TRAILER CARGO LIGHT WEIGHT, MC2  
REPLACEMENT OF STOP-TAIL LIGHT ASSEMBLY

MODIFICATION INSTRUCTION

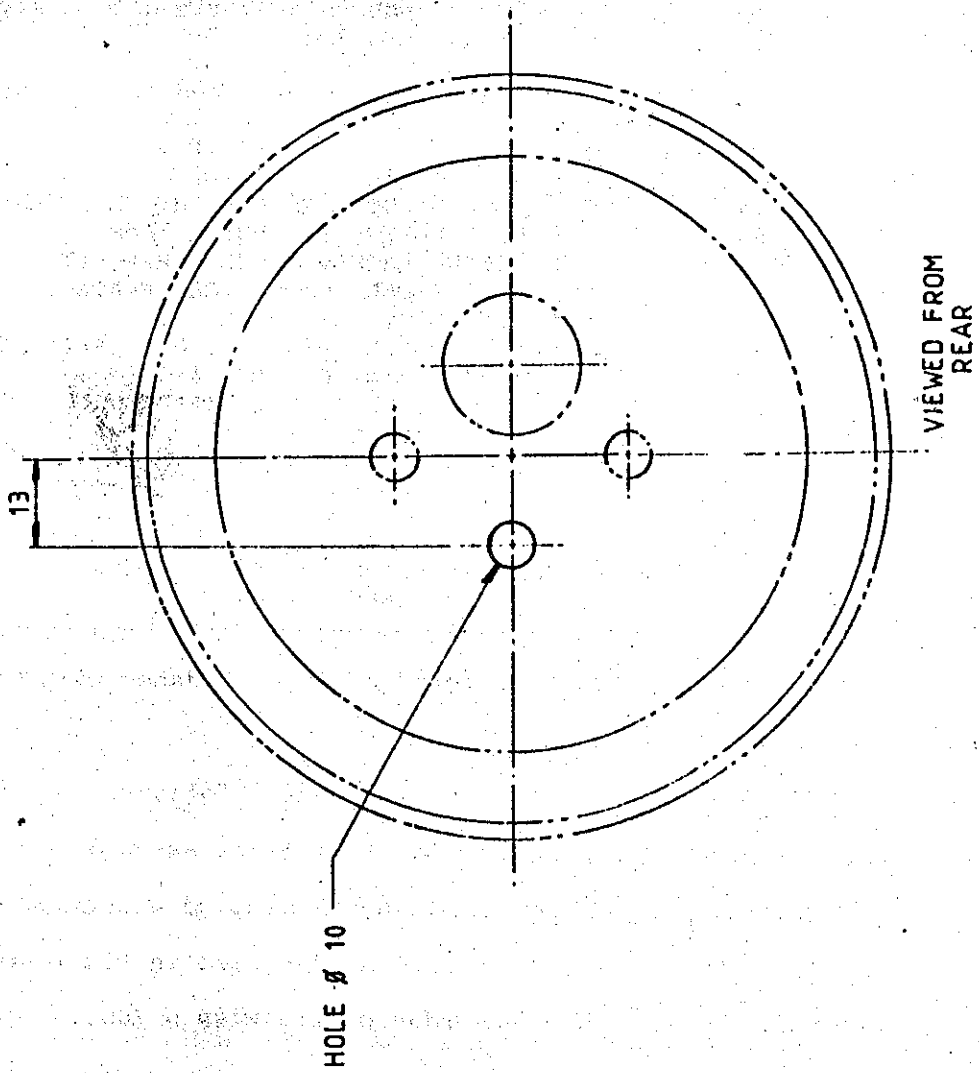
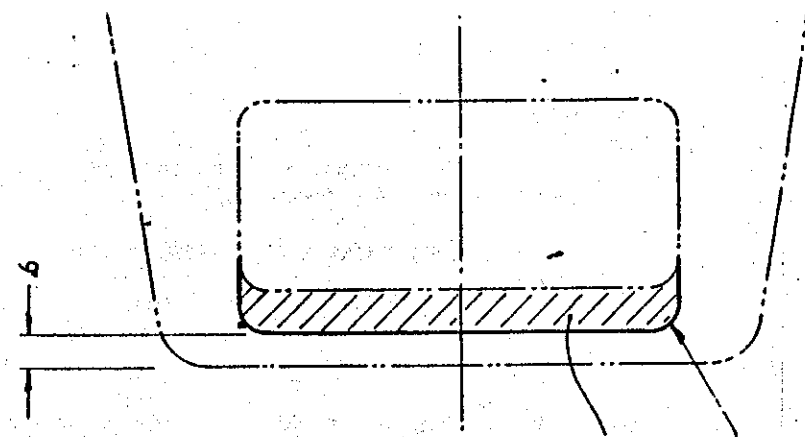
8. To carry out the modification proceed as follows:
  - a. Disconnect the wiring to the tail light assembly.
  - b. Remove the existing tail light and shroud assembly.
  - c. Modify the tail light shroud as detailed in Fig 1 and shown in Fig 2 and 3.
  - d. Paint the shroud in accordance with WKSP B 700.

REMOVE SHADED  
AREA

FIG 3 - BASE OF MODIFIED TAIL LIGHT SHROUD

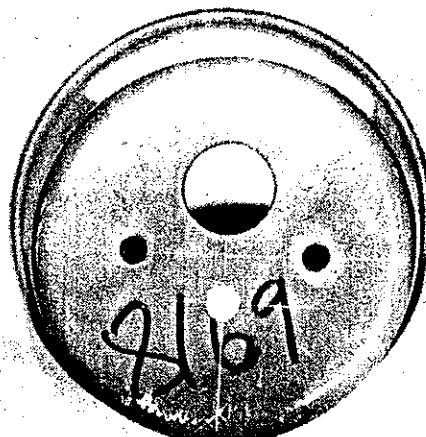
- e. Disassemble the new stop-tail light assembly (item 1 Table 1) and correctly fit the lower section of the light into the modified shroud.
- f. Using the shroud as a template, mark and drill the two existing shroud mounting bolt holes in the base of the tail light lower section.
- g. Remove the grommet from the lower section and insert it into the 10 mm hole drilled in the base of the shroud.

FIG 4 - LOWER SECTION OF TAIL LIGHT AND SHROUD SECURED TO TRAILER

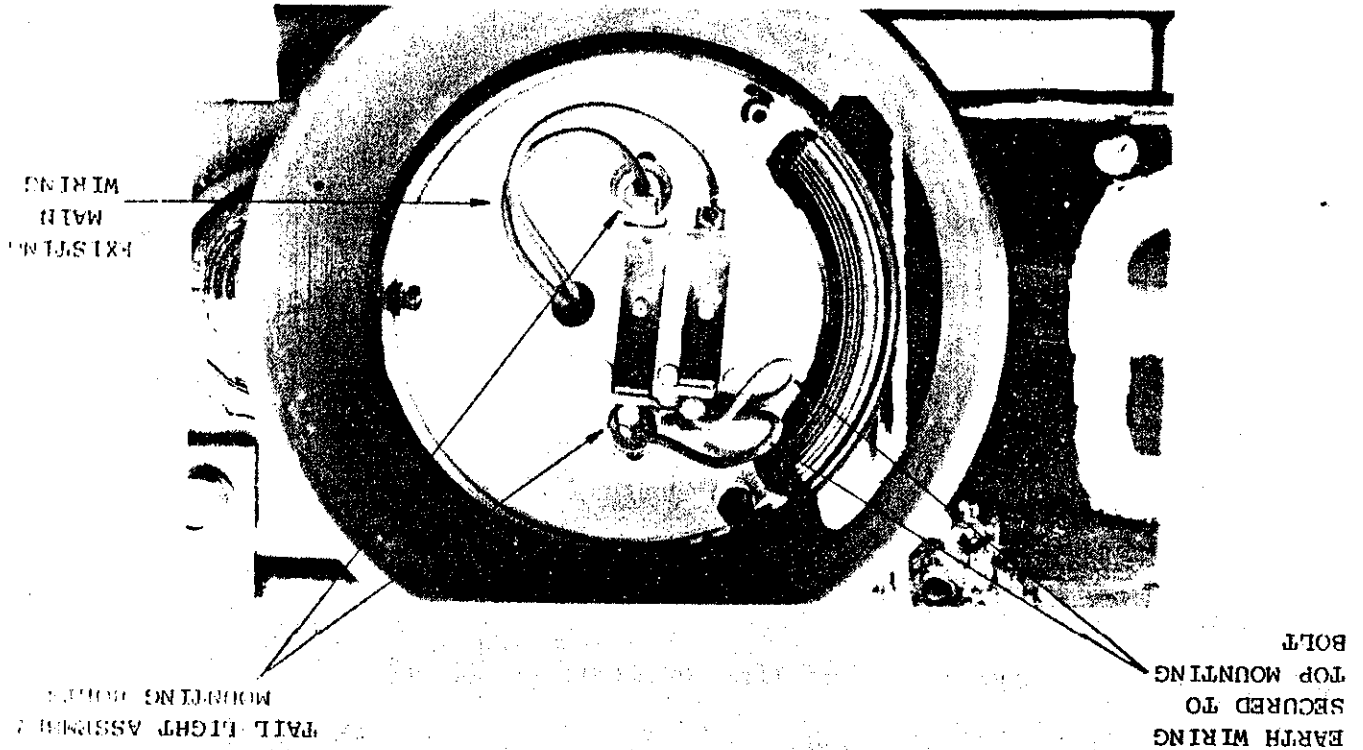
- h. Using item 2 from Table 1 and suitable crimp terminals:
  - (1) manufacture the two earth wires as shown in Fig 4, and
  - (2) if necessary, lengthen the existing stop-tail light wires to enable wiring of the new type tail light.
- i. Fit the lower section of the tail light into the shroud and using items 3, 4, 5 and 6 from Table 1, secure to the existing mounting bracket ensuring that:
  - (1) the two earth wires are secured to one of the mounting bolts as shown in Fig 4, and
  - (2) the tail light wiring is passed around the outside of the mounting bracket and through the grommet in the base of the shroud as shown in Fig 4 and 5.
- j. Seal around the mounting bolt holes with a suitable sealant to prevent water entry.

- k. Fit the festoon bulbs (items 7 and 8, Table 1) to the tail light assembly.
- l. Connect all wiring to the tail light as shown in Fig 4 ensuring that correct circuitry is maintained.
- m. Test the tail light and stop light for correct operation.
- n. Fit the seal and lens as shown in Fig 6 and 7.

FIG 5 - TAIL LIGHT SHROUD SECURED TO TRAILER

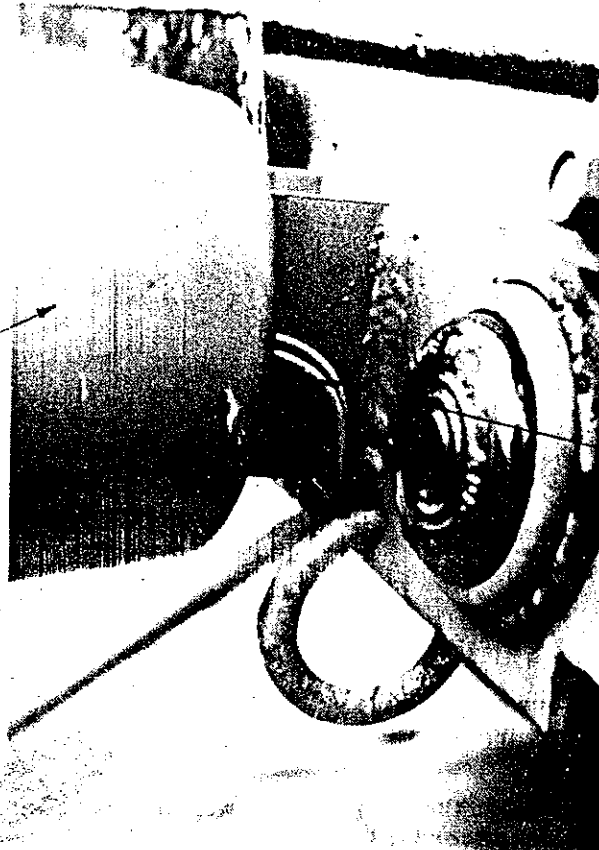
TAIL LIGHT WIRING  
PASSING AROUND  
THE OUTSIDE OF  
THE MOUNTING  
BRACKET AND  
THROUGH THE  
GROMMET IN THE  
SHROUD BASE
